TRAFFIC SAFETY COMMISSION

THURSDAY, MARCH 12, 2026, AT 3:30 PM

2026 Mill and Overlay striping and signage

2026 Street Rehabilitation Project Recommendations

4th Street Ivinson to Flint current striping between Fremont and Clark Streets:

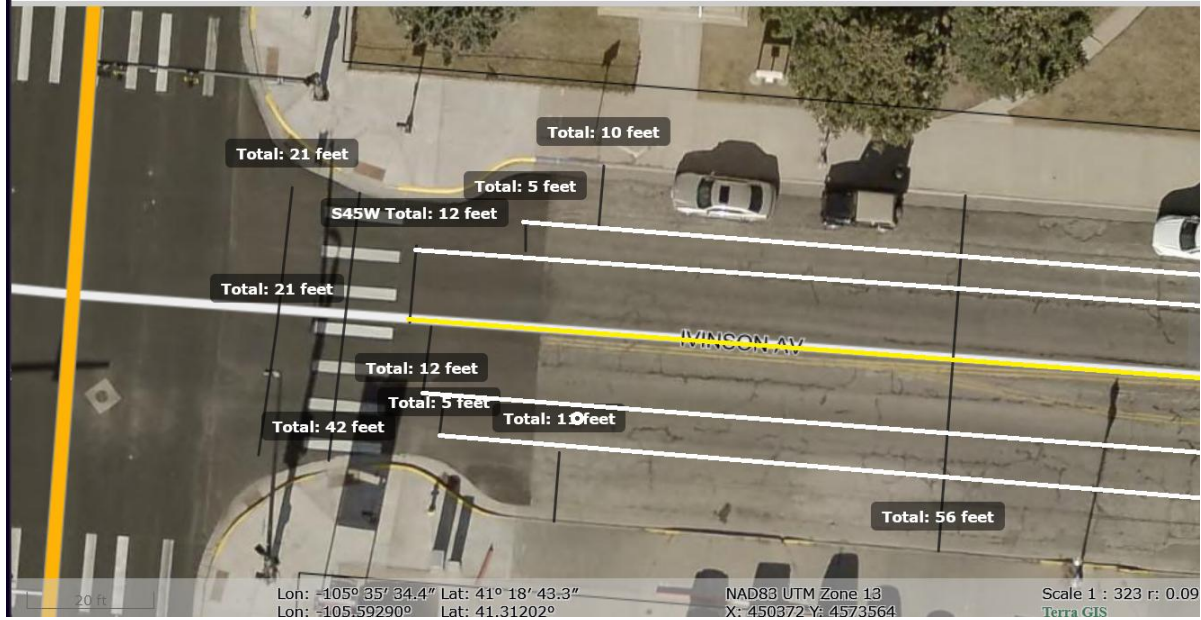
Put the center lane in center of the street, change vehicle travel lane to 11 feet, adding 2 feet to each parking/bike lane.

Center lane in center of street, change vehicle travel lane to 11 feet, adding 2 feet to each parking/bike lane.
